2/21/2024 | 6:00 PM

**MUNICIPAL SERVICES CENTER, COUNCIL CHAMBER
3600 TREMONT ROAD**

1. Consent Agenda

Preferred Roofline

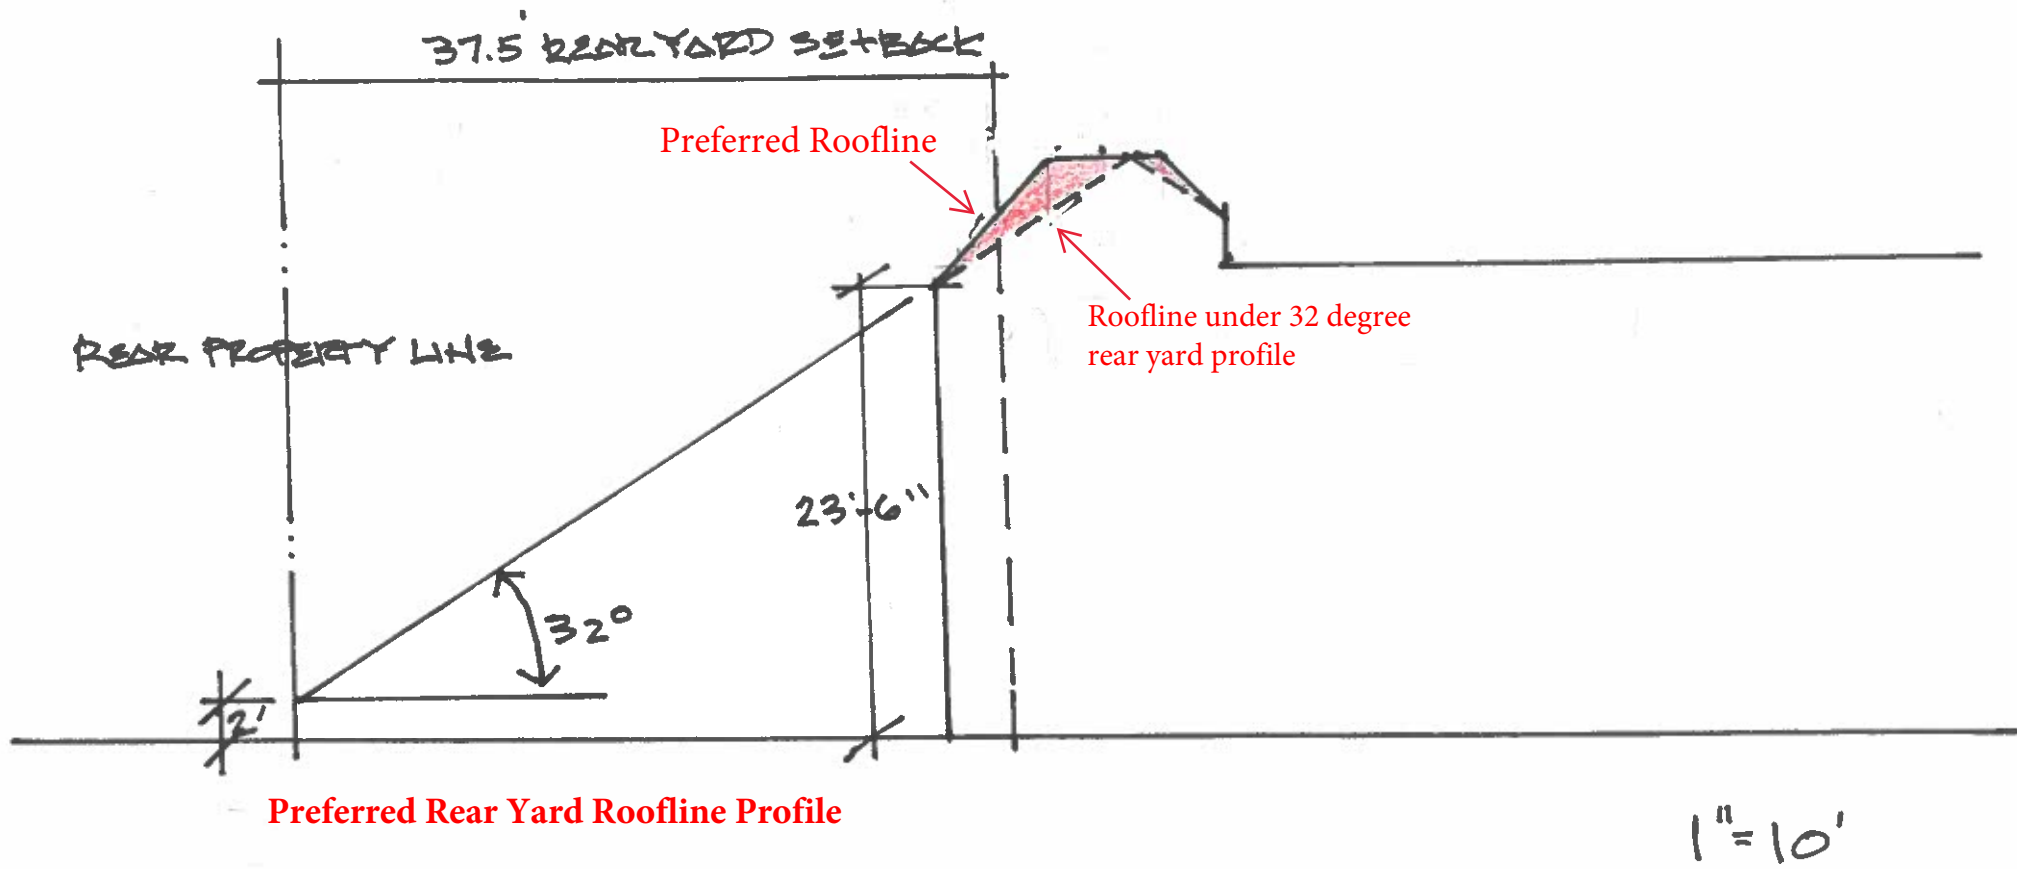
Since the Work Session, the two-story portion of the addition has been modified to include an irregular hipped roof at the front and rear of the addition that reduces the area of projection into the rear yard profile. The roof angle remains the same as the existing main roof (45 degrees). The rear yard setback was also corrected on the plans, which originally showed a 40-foot setback when it is actually 37'-6".

Third-Party Architect Sketch (Side)

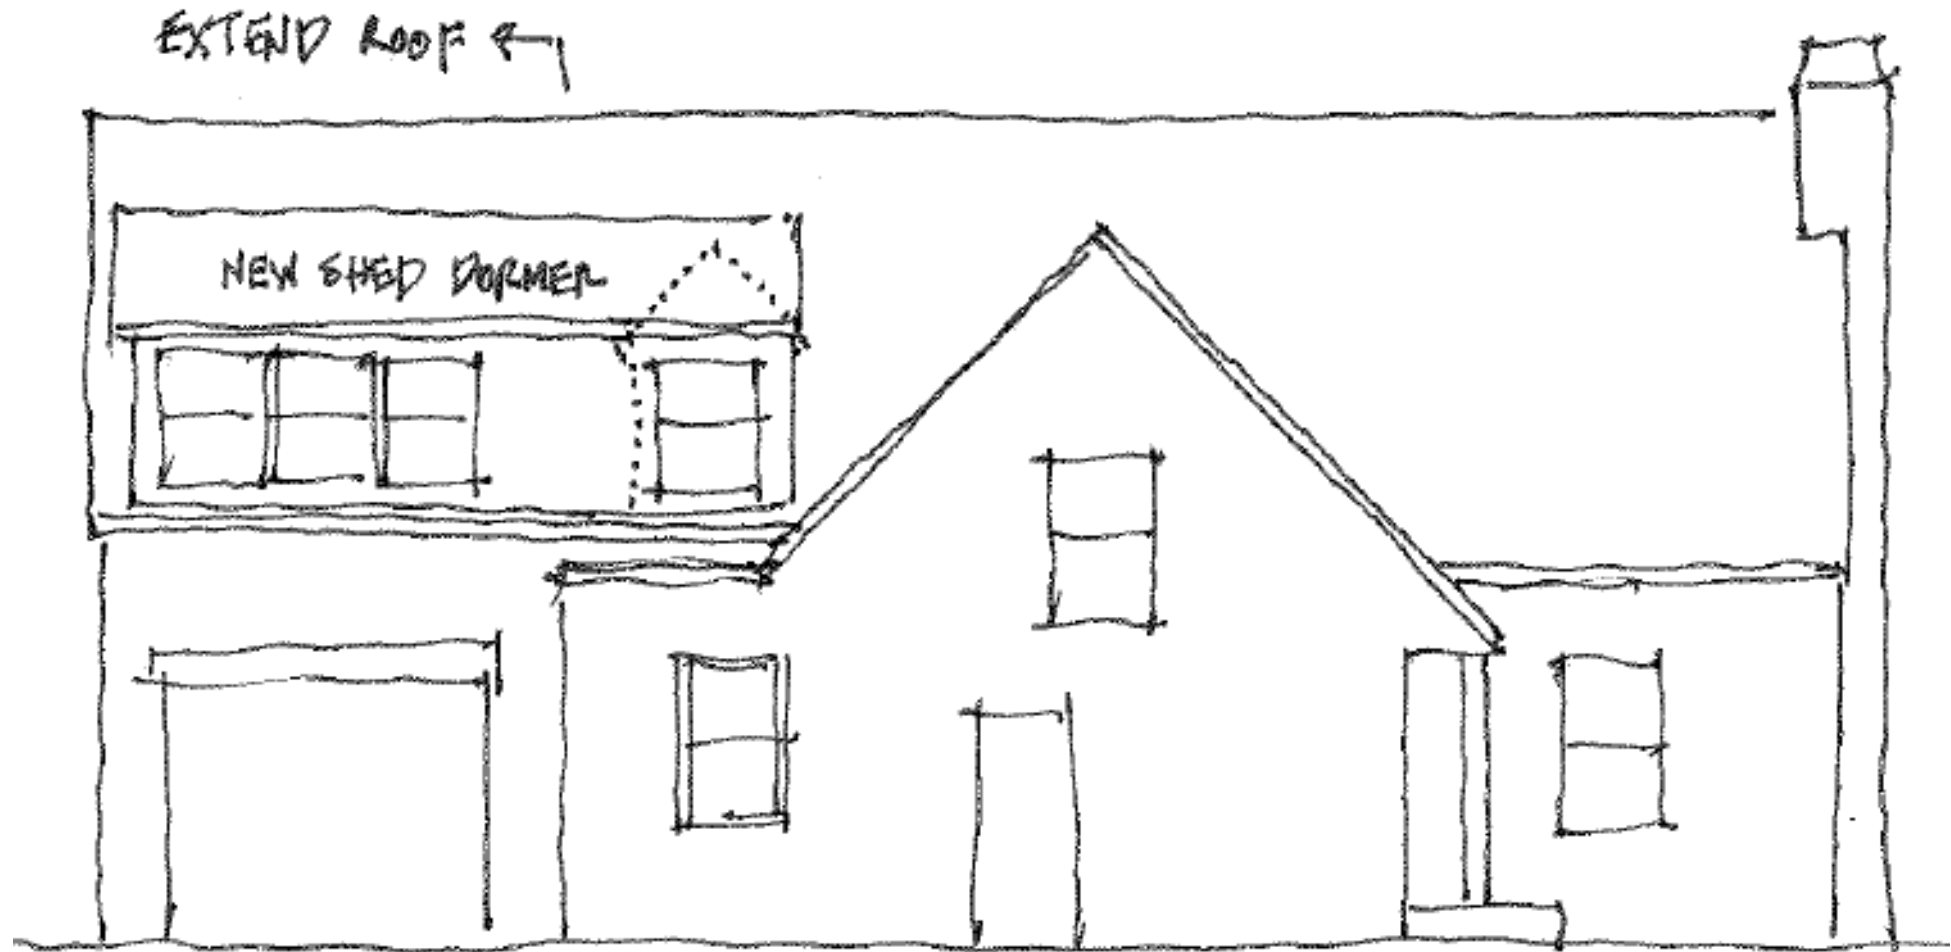
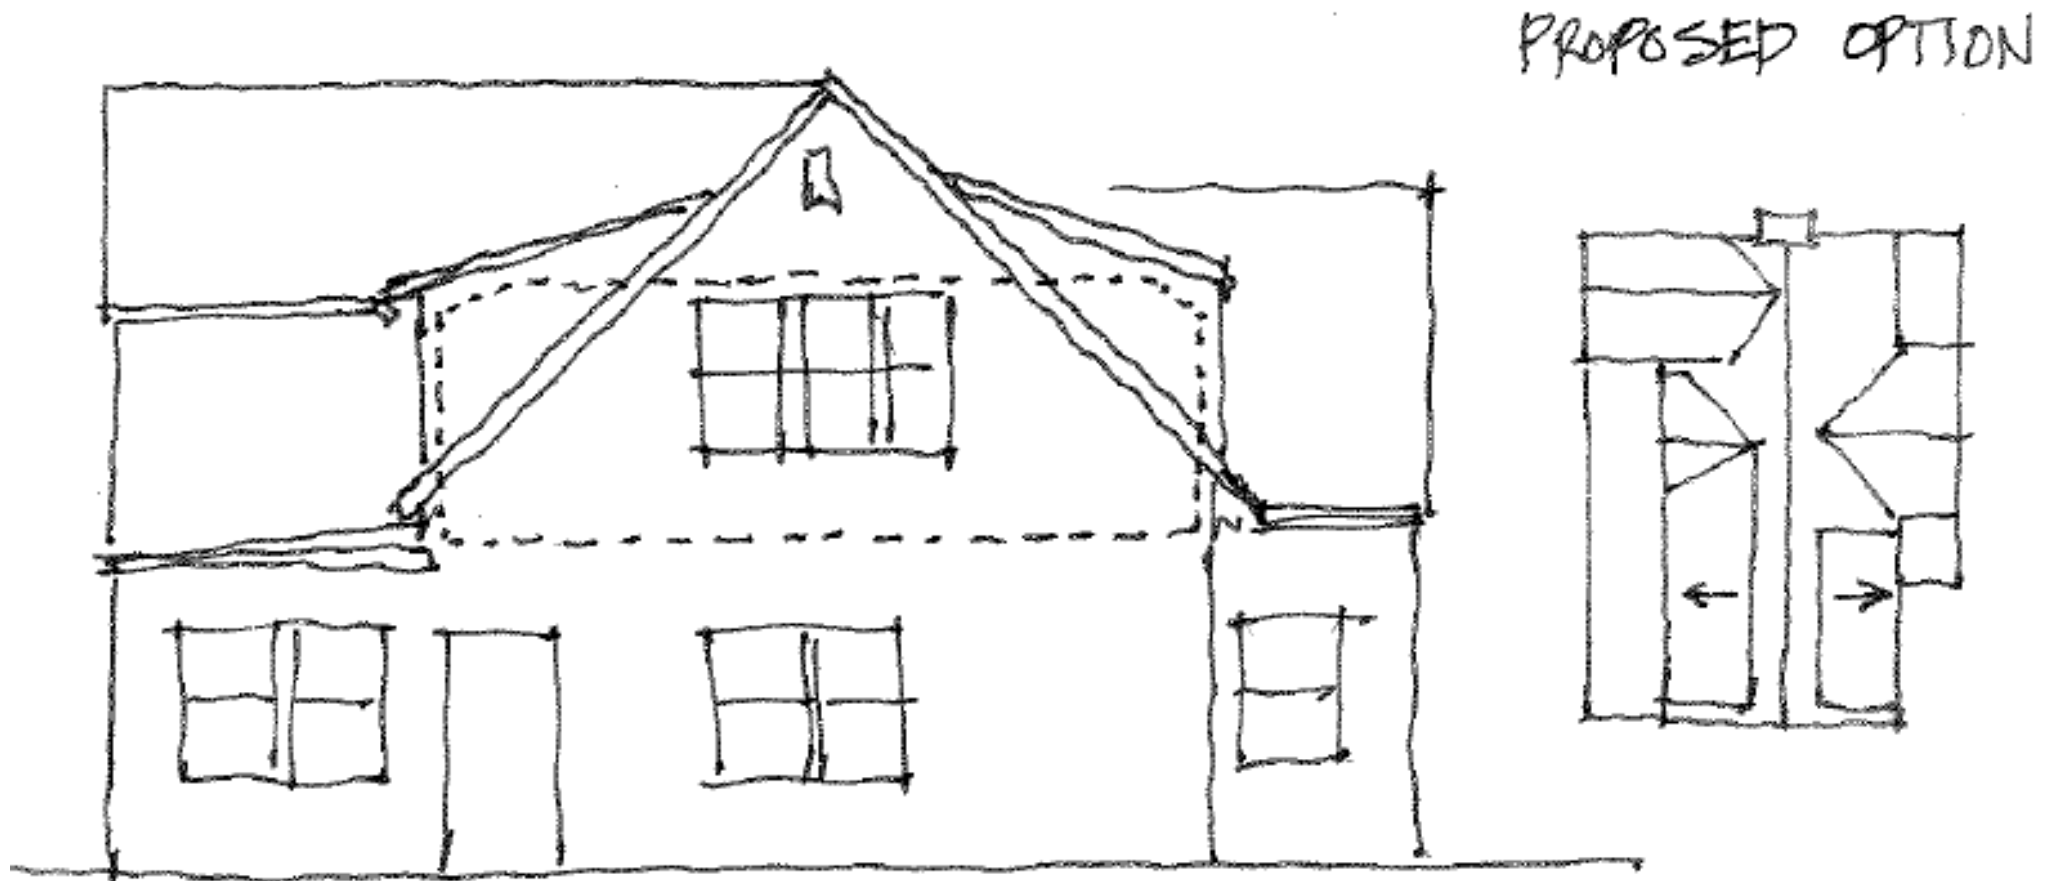
The City's third-party architect shared the following comments in relation to the massing of the addition (see related sketch in attachments): *"I'm having a hard time understanding how the proposed solution was generated. The shape of the addition seems incredibly contrived to me (inappropriate for the existing home). Why not simply extend the existing main roof and add big shed roof dormers on the side? It appears that new shed roof dormers would pick up much more interior space than the proposed submittal."*
